**NEW MEXICO ENVIRONMENT DEPARTMENT  
INSPECTION OF PUBLIC RECORD REQUEST FORM**

1. NMED's technical completeness determination or additional request for information on New Mexico Copper Corporation's discharge permit application, date range June 28, 2017 through July 19, 2017;
2. NMED determination regarding Copper Flat Copper Mine pit lake being a private water, date range June 28, 2017 through June 19, 2017;
3. Bureau of Land Management request to the Surface Water Quality Bureau to write a letter of concurrence for the Surface Water Quality Bureau's benefit regarding the proposed Copper Flat Copper Mine pit lake and associated patented claims surveys completed and a

To: Shelly Lemon, Chief, Surface Water Quality Bureau  
Michelle Hunter, Chief, Ground Water Quality Bureau  
From:  Melissa Y. Mascareñas, Department Public Records Custodian  
Date: September 6, 2017  
Subject: Request to Inspect Public Records

Figure 2. Groundwater flow direction.

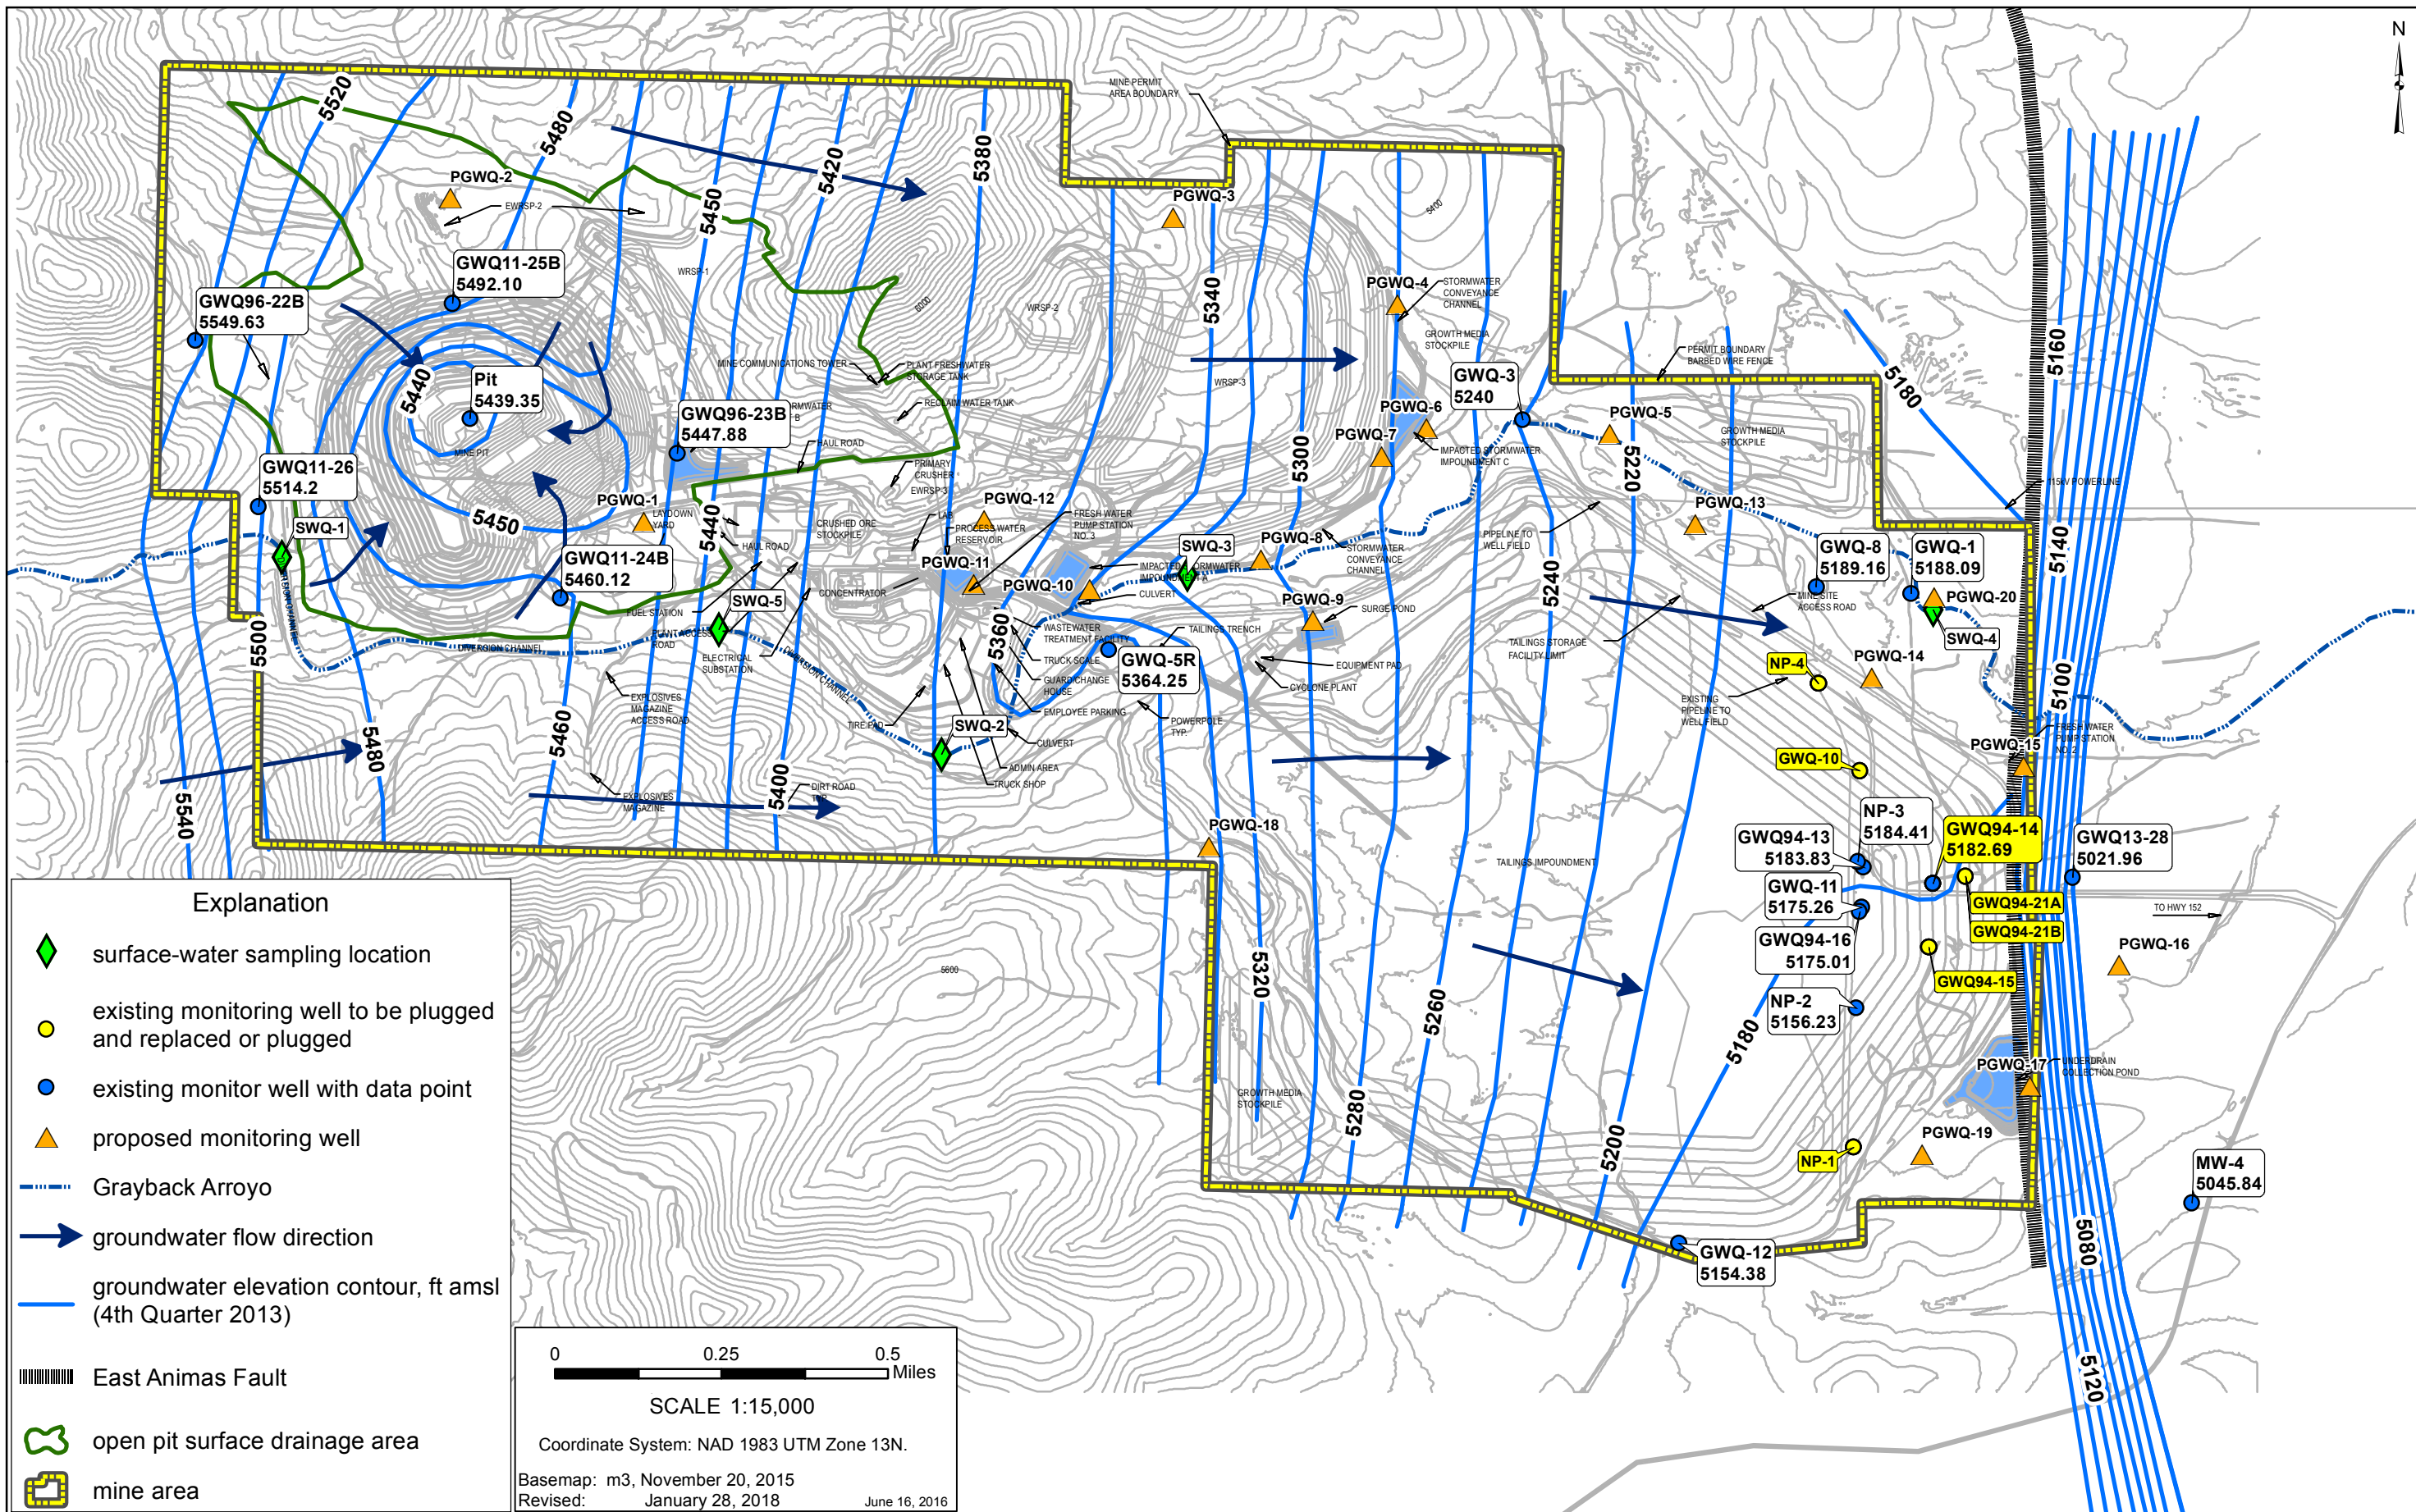
Per our discussion, a revised version of Figure 2 for Appendix E Rev 1, *Water-Quality Monitoring Plan for the Copper Flat Mine Discharge Permit Pursuant to 20.6.7.11.R and 20.6.7.28 NMAC*, June 2016 by JSAI, Part of NMCC's Discharge Permit Application, is attached.

This revised Figure 2 includes surface-water sampling locations.

**Figure 2. NMCC Boundary Plat Overlaid on BLM Survey**  
 Source: BLM Cadastral Survey

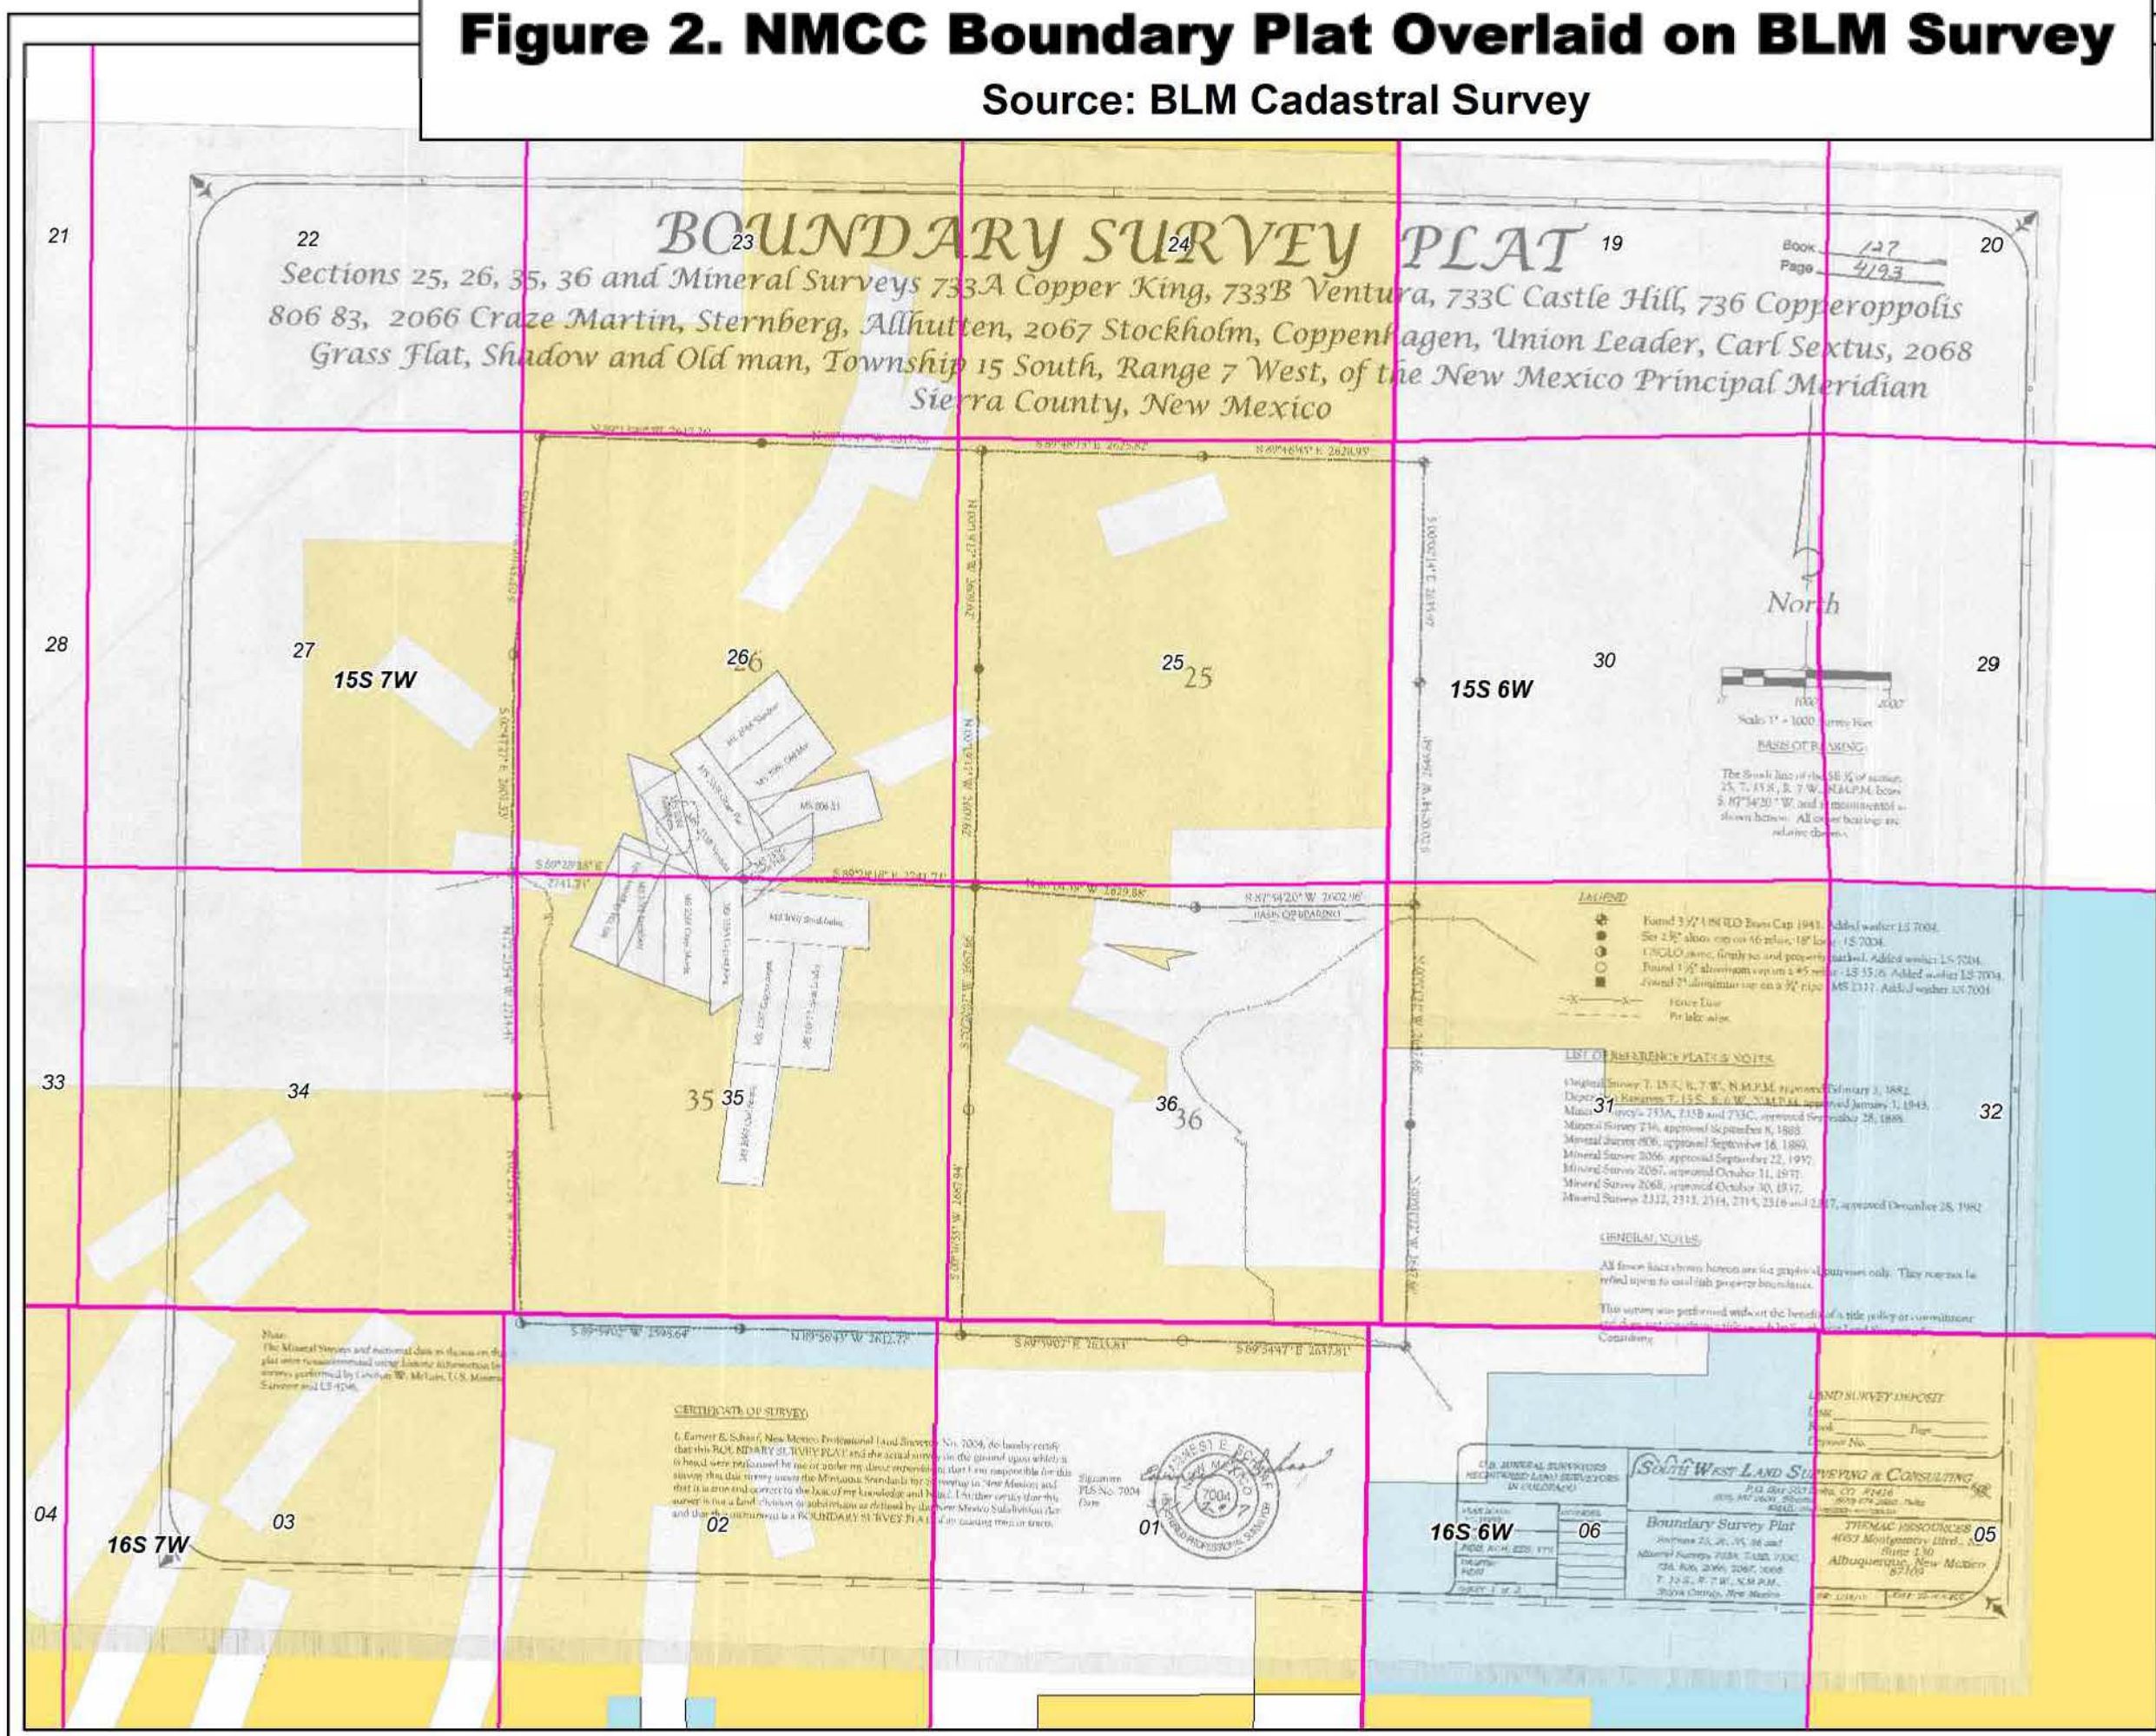
Figure 2 was developed by Mr. Stephen Beyerlein, a land surveyor in BLM's cadastral survey office in Santa Fe. To create this figure, Mr. Beyerlein overlaid the NMCC property plat onto BLM property maps that are maintained by the BLM cadastral survey department. This figure confirms that the private property boundaries mapped by NMCC align with BLM survey information. Mr. Beyerlein states in his October 12 email (provided with figure 2) that "this [overlay] should be evidence for the State or anyone else that you are in the proper location." On December 12, Mr. Beyerlain further clarified that regarding this figure "it was our (i.e. BLM's) intention to show that the claims are on private land."
